## ANN ARBOR DESIGN REVIEW BOARD

### Staff Report

**PROJECT:** The Gallery (formerly The Jefferson)  
Project No. DR16-018

## MEMO

Urban Landscape Park Concept

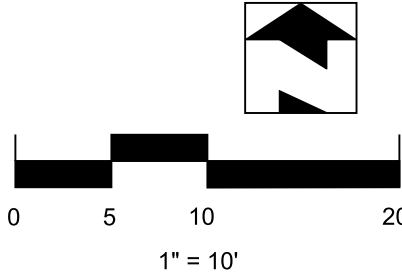
3. Enhance the landscape plan to better reflect, and celebrate, the underlying drain and the existing floodplain across the site. The proposed foundation plantings are too suburban in nature, and too diminutive in scale, for the site. ***A Landscape Architect has been retained to focus on this. His first pass shows these elements. We are continuing to explore various treatments at/of this area and may have additional options to show the board at the March meeting.***
